Project Narrative: Byers Chevrolet Grove City #201401280003 Development Plan Submittal (Rev. 02/24/2014)

Comment Responses: Byers Chevrolet of Grove City #201401280003 **Development Plan Response Submittal (02/24/2014)**

The following is a summary of the clarifications and modifications made to drawings in response to comments/recommendations letter dated February 11, 2014.

Sheet Title
ARCHITECTURAL SITE DETAILS

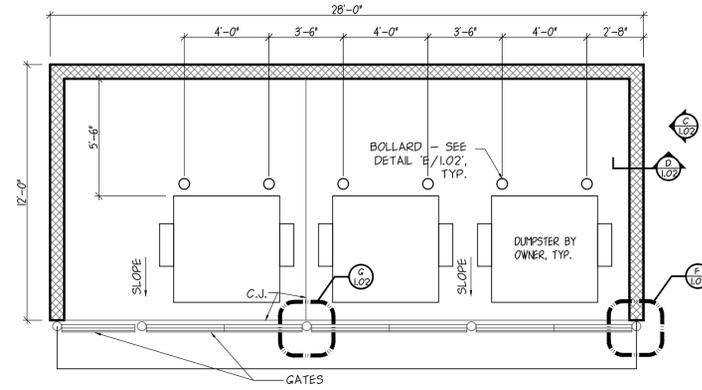
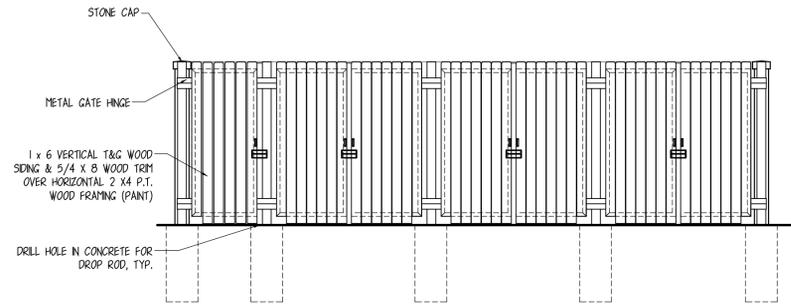
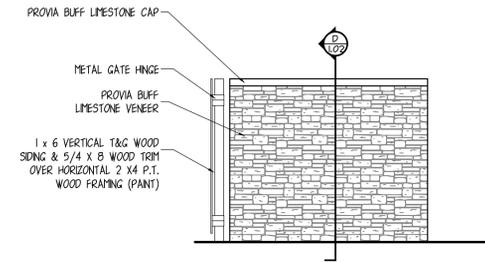
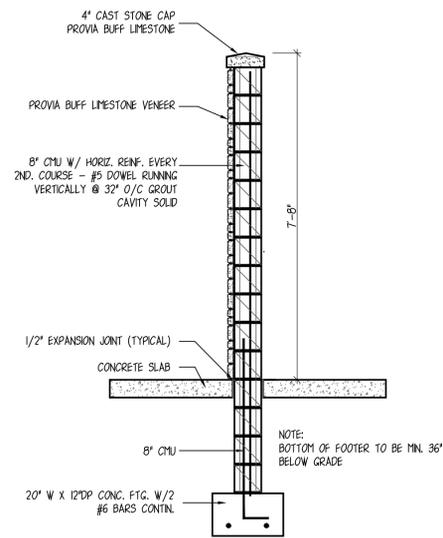
8. All rooftop equipment is being located such that it will be screened by raised parapets. A note indicating such has been added to the elevations.
9. Details on the proposed dumpster enclosure are being provided. The enclosure materials match that utilized on the main structure as indicated.

OVERALL LANDSCAPE PLAN

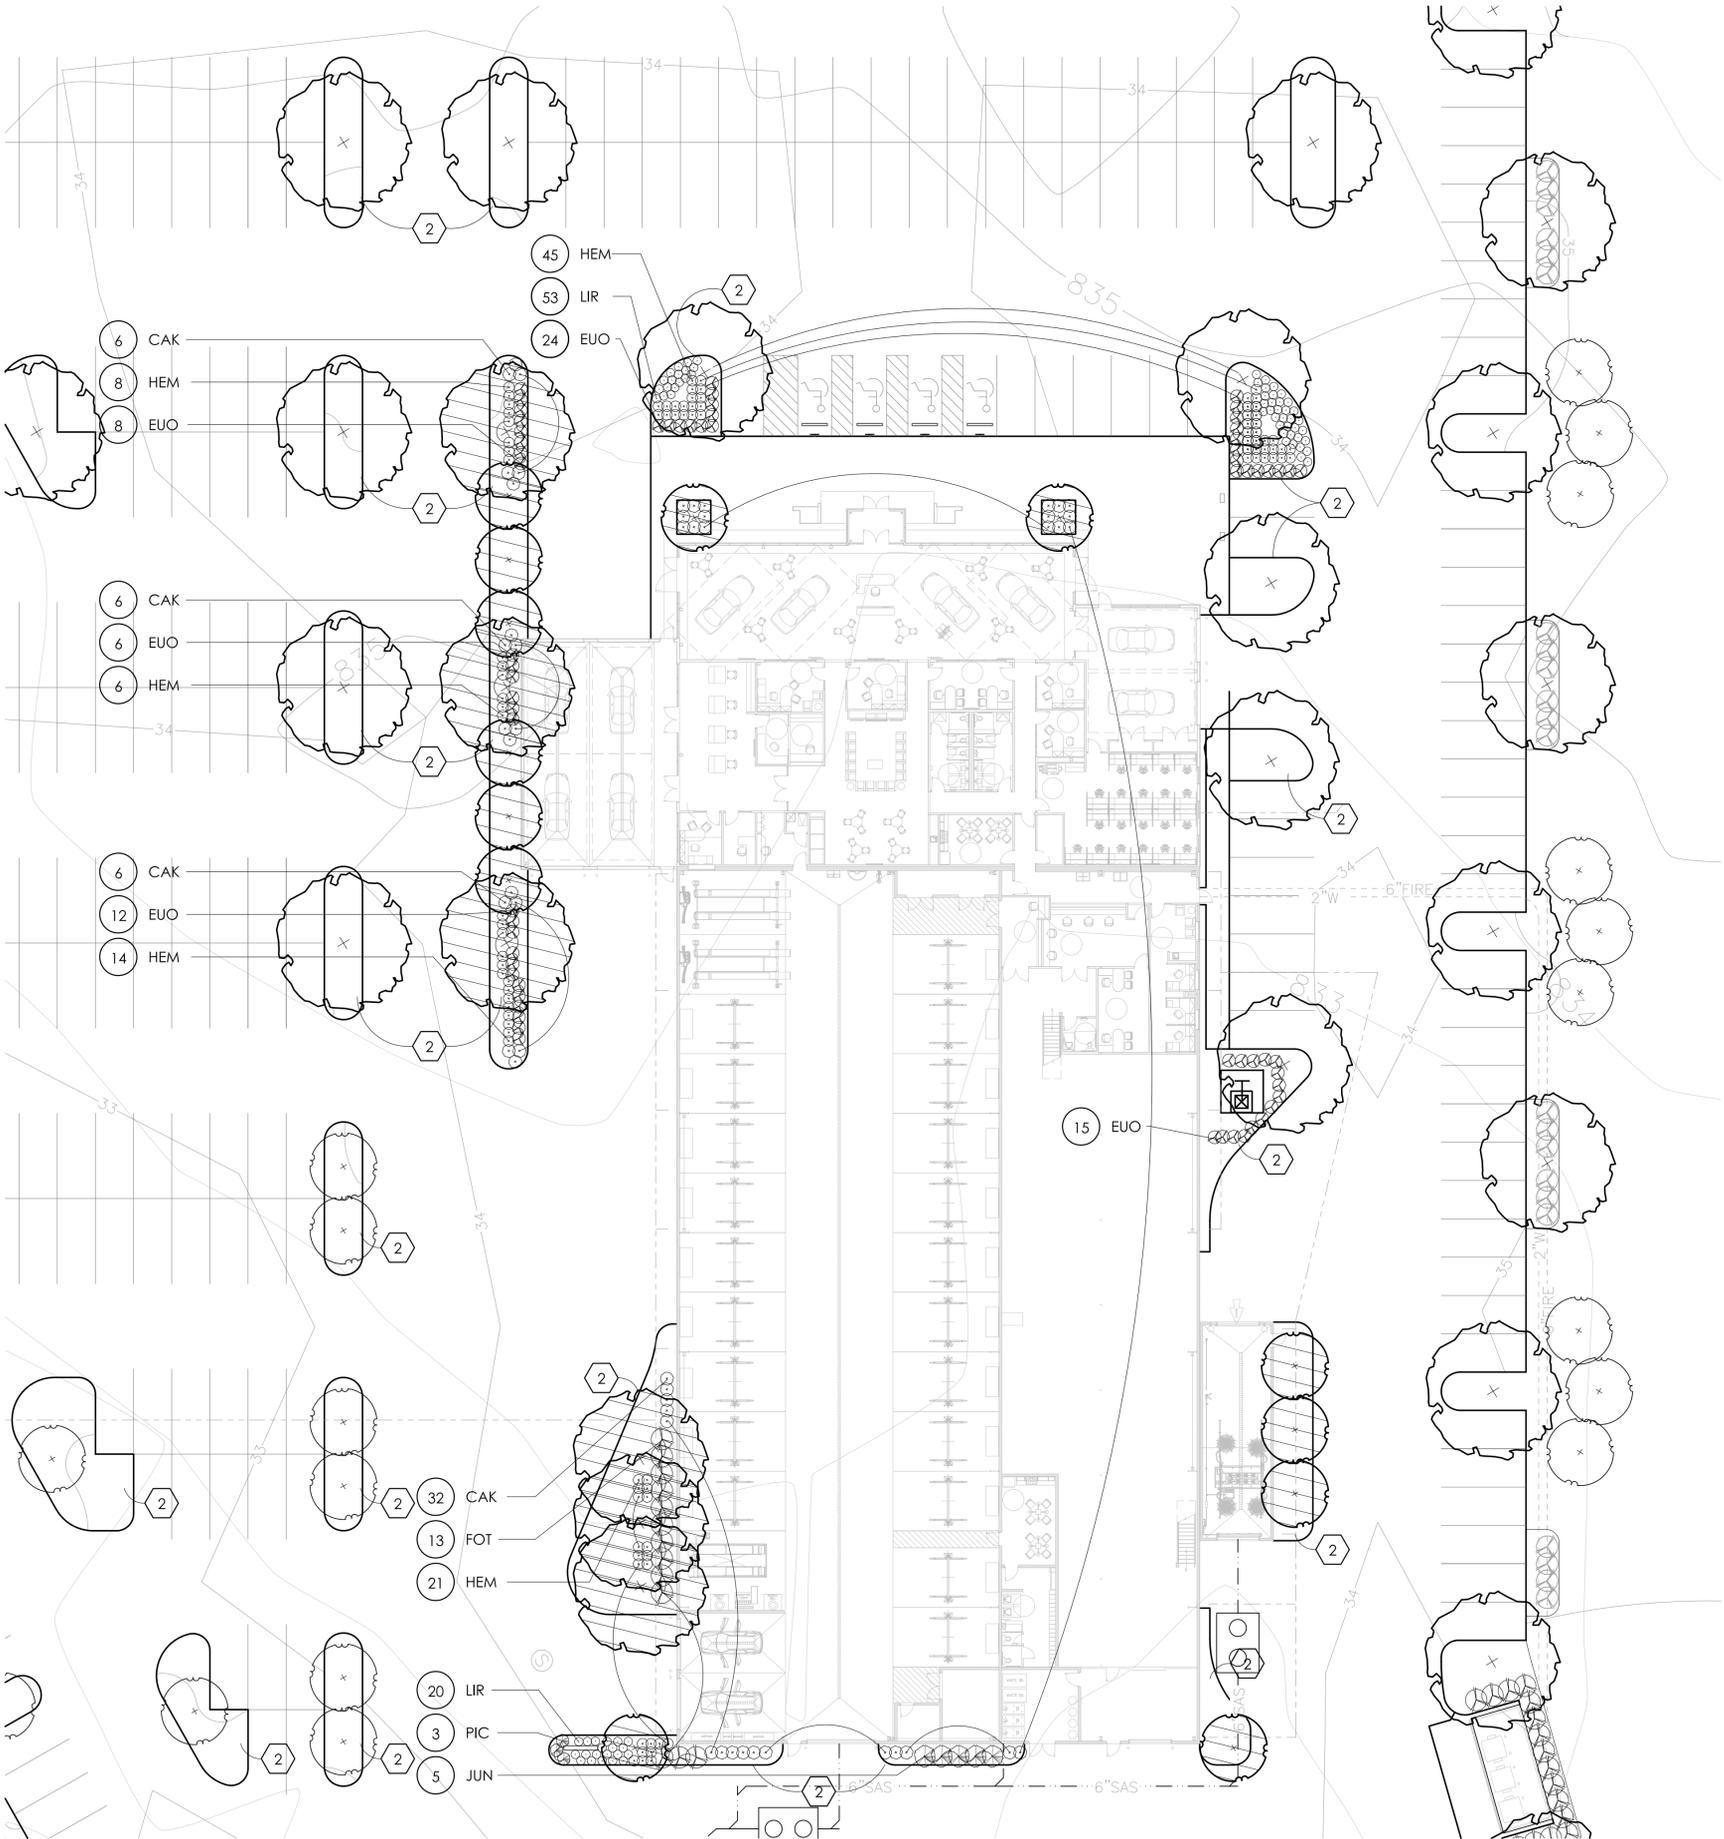
24. The code states that tree planting around detention areas be placed 20' from bank. Given the site constraints between the pond and electric easement, we are requesting that tree be allowed closer than 20' to bank of detention.

*3 - APPLICANT ASKS FOR WAIVER OF 20' SETBACK REQUIREMENT FROM BANK OF POND TO PROVIDE ROOM FOR PLANTING AND ACCOMMODATE EXISTING ELECTRIC EASEMENT.

② BUILDING PERIMETER ENLARGEMENT PLAN
 SCALE: 1" = 20'

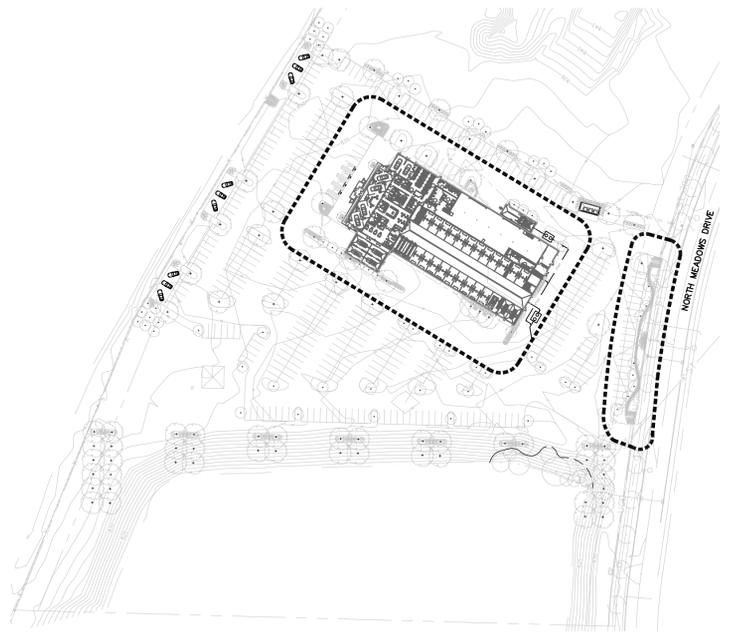
29. Note has been added that states all service structures including but not limited to A/C units, electrical transformers, & trash dumpsters shall be screened per 1136.08
